**Re: HS2 Schedule 17 Application – Bacombe Lane to Nash Lee
Objections to Technical Submission**

Planning Application PP-11486973 19/8/22 Schedule 17 AVDC P04 Nash Lee. . Objection 1; HS2 Nash Lee Noise Demonstration Report

Figure 1; Coombe Hill Aquifer Diversion

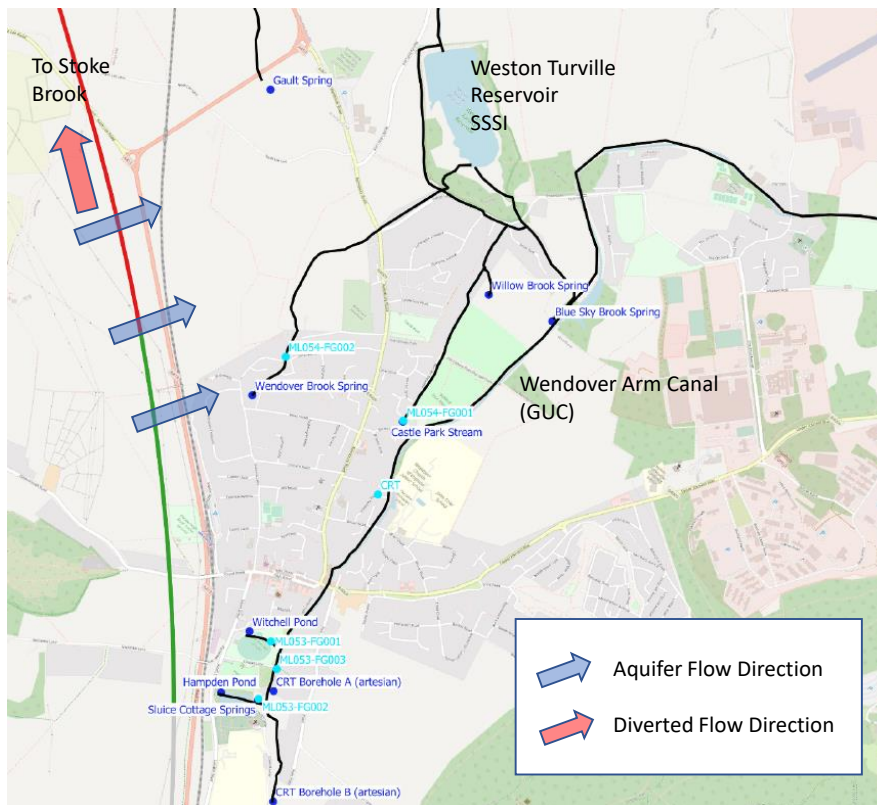
The area of development covers an area with various chalk bedrock formations with aquifer properties situated in the upper Thames catchment. The Coombe Hill aquifer feeds various springs in Castle Park and Wendover Brook that in turn feed the Weston Turville SSSI, as shown in Fig 1. The ecology of the SSSI is particularly sensitive to maintenance of water levels and any reduction in water fed by the current stream system would have to be drawn from the Wendover Canal (and trust) at Blue Sky Brook.

The railway cutting in this section bisects the aquifer below the level of the natural water table and the scheme proposed shows a “low permeability wall” and a shallow filter drain that will divert aquifer water and discharge it into Stoke Brook.

- iii) The proposed a scheme of mitigation, by diverting storm water to Hampden Pond via holding ponds, South of the Green Tunnel portal and from there to be discharged into the Wendover Arm canal, should be considered. There is a sluice which already discharges into Blue Sky Brook that could be used to provide replenishment water to the Weston Turville SSSI reservoir. The mitigation proposal would therefore reduce the risk of increased storm flows in to Stoke Brook which is already susceptible to flooding risk in the Aylesbury conurbation.

Figure 2; Marked up extract from Landscape_Planting_Plan_Sheet_2_OF_2-2419788.pdf

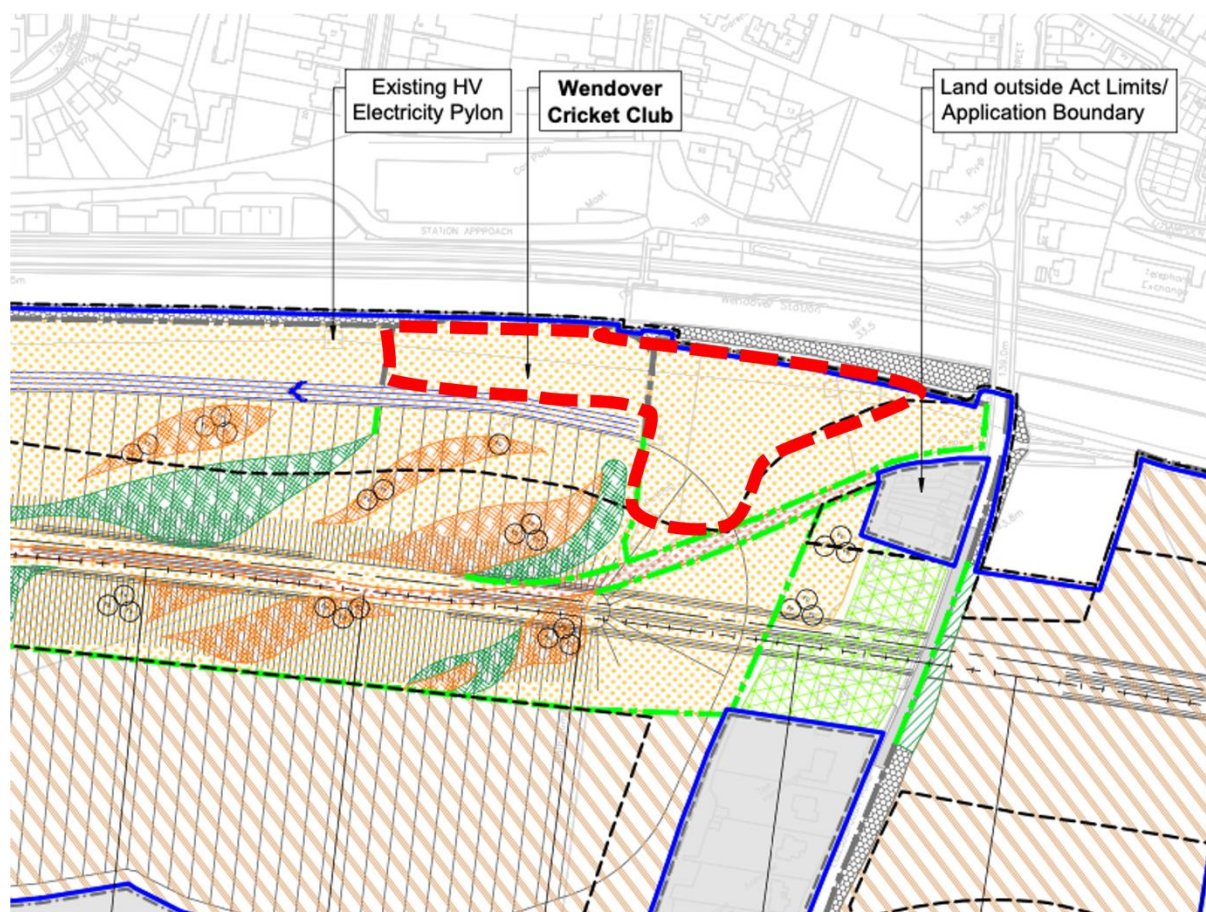
However, the landscape design in the submitted proposal has significantly reduced the area available due to extension of the eastern face of the Green Tunnel and presence of a surface drain, as shown in Figure 2 below. This restricts the reinstatement of the land as a levelled community amenity, allowing creation of a football pitch, netball or tennis courts; or a flexible event space.

- i) Recognising that the Indicative Mitigation plans are currently for consultation and should be subject to future Schedule 17(9) submissions; the Council has powers under Schedule 17(8) for land restoration; that the council should demand that HS2 Ltd reinstate a recreational amenity in a similar location to the land previously used by the Cricket Club. We note that a new Cricket Ground is planned at Tring Road, but this is not a suitable replacement for the other non-cricketing users of the recreation ground close to the village.

Figure 2, EKFB PRoW diversion, from Scheme Design "Earthworks and Drainage Layout", Rev C01, October 2019.

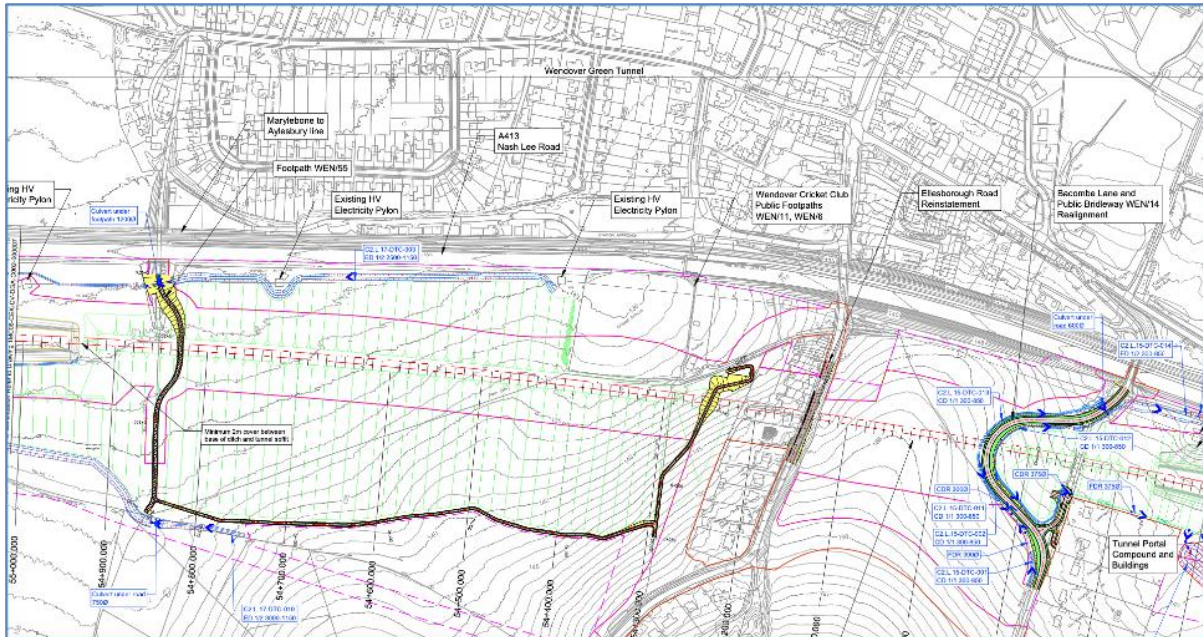
2. The WEN/11/1 and WEN/11/2 route needs to have a suitable gradient to rise up the side of the green tunnel at chainage 54+280 or thereabouts. In the scheme design this was anticipated as a hairpin diversion with a potentially visible cutting, presumably to provide a flat surface route.

Figure 3; Extract from the “Landscape Planting Plan, sheet 2 of 2 - 2419788”

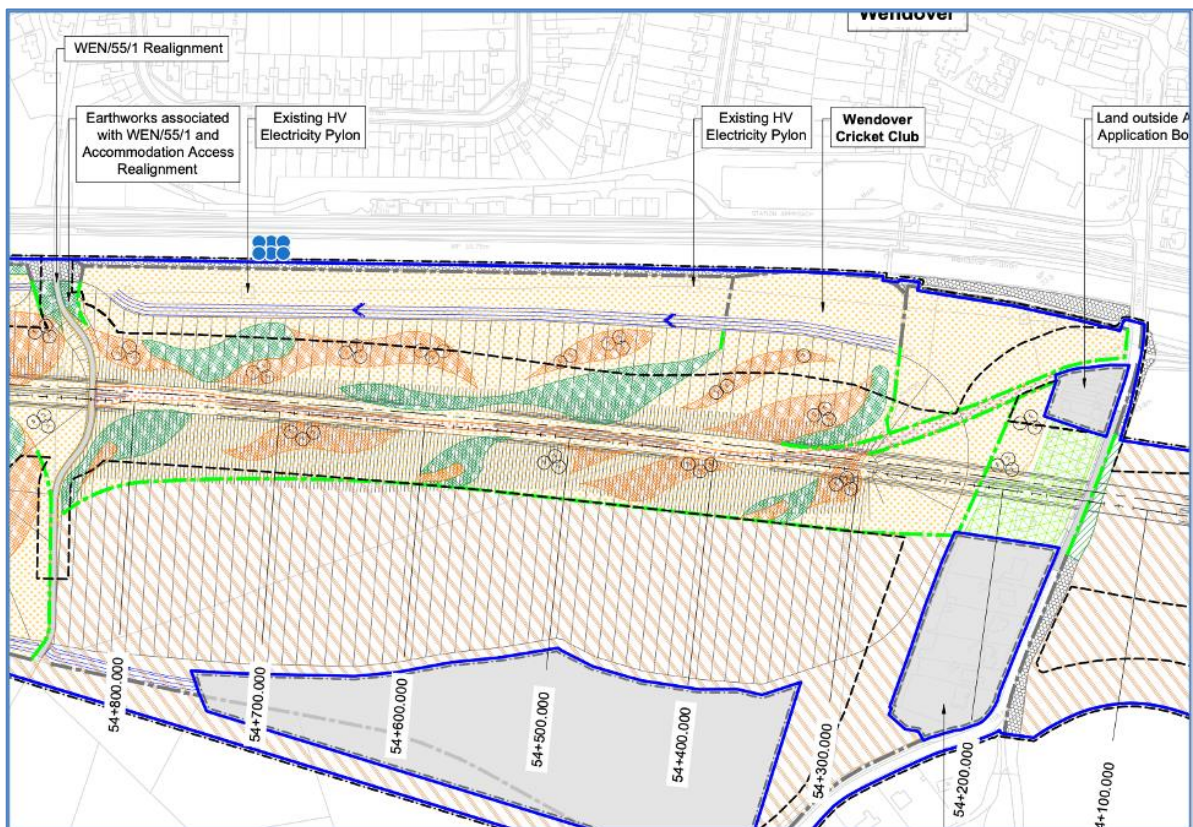
1. There does not appear to be any provision to reinstate the link between Wendover Station and Ellesborough Road, previously formed by WEN/11/1 and WEN/11/2.

Consideration is also needed for the observation platform now proposed in the submitted “Environmental Master Plan Indicative Mitigation Letter – 2420017”, and also the interchange with the new Wendover Link “Greenway” North and South junctions as proposed in the HS2 Chilterns AONB Design Review Group Detailed Design Principles (as shown in Figure 5). The actual design of the Wendover Link is not detailed in the Landscape Plan shown in Figure 3 above.

- i) The Council should demand further design detail to ensure that all the existing PRoW routes will be re-instated and construction of the new “Wendover Link” committed as components of the project funded by HS2 Ltd.
- ii) While the Indicative Mitigation plans are currently only for consultation; the Council should be aware of the potential for Visual Impacts in the AONB associated with the reality of the impact of the line on the local PRoWs. The Council should demand further design detail for landscape visual impact assessment during this Schedule 17(3) process rather than attempting remediation during future Schedule17(9) submissions.

Figure 4; Anticipated natural routes for WEN/6/2, WEN/6/3 (dashed), and WEN/11/2 (dotted)

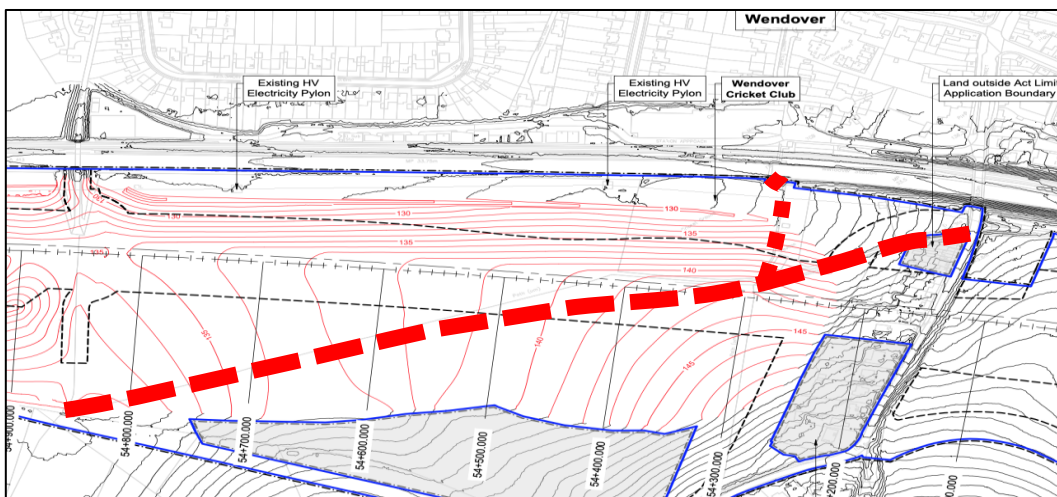
3. The WEN/6/2 (Aylesbury Ring) route diagonally across the field (from the junction with WEN/55/1 to the Cricket Ground) has been diverted across the western edge of the Land Available for Use which is appropriate during the works. However, retaining this as a permanent feature (as suggested by the Scheme Design) is unlikely to be effective as the natural route used by walkers between the two points will be a diagonal path due to the contours of the eventual landform as shown in Figure 4 .
